90-09-10 TEXAS INSTRUMENTS: Amendment 39-6565. Docket No. 89-ANE-38.

94-21-06 PACIFIC SCIENTIFIC COMPANY, HTL/KIN-TECH DIVISION:
Amendment 39-9048. Docket 94-NM-73-AD.

Examples of Bolt Head Markings
FIGURE 2

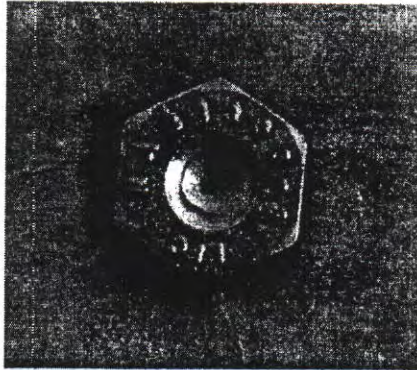
3. Verify the installed bolts are the approved part numbers NAS1303 or NAS6603. If approved bolts are installed proceed to Step 6. Refer to Figure 2.
4. Remove and replace any unapproved bolt part number with an approved bolt part number. Refer to 1124/1124A Westwind Illustrated Parts Catalog, Chapters 54-20-00 and 78-30-00 for proper bolt part numbers.
